PARKSIDE INQUIRY

WRITTEN STATEMENT STRATEGIC RAIL FREIGHT TERMINAL PROPOSITION AND VIABILITY DAVE TYAS, BEng

PARKSIDE ACTION GROUP

PARKSIDE LINK ROAD (PLR)

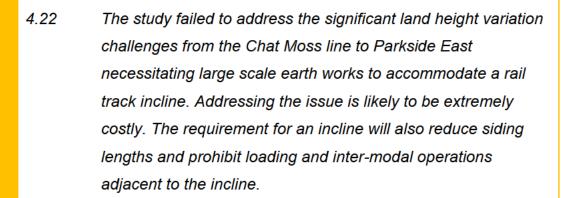
- 4.18 Loading and inter-modal operations for warehouse locations 8, 9, 10, and 11 would be compromised being adjacent to the track incline.
- 4.19 At the end of the incline there would be limited track length compared to the original solution envisaged.

- 4.20 The 2016 AECOM RFI Study did not include an assessment of a an RFI configuration that coexisted with the PLR as the PLR proposal came forward after the report.
- 4.21 For configuration option 4 in the study, it is clear the track and sidings will need to be relocated further East
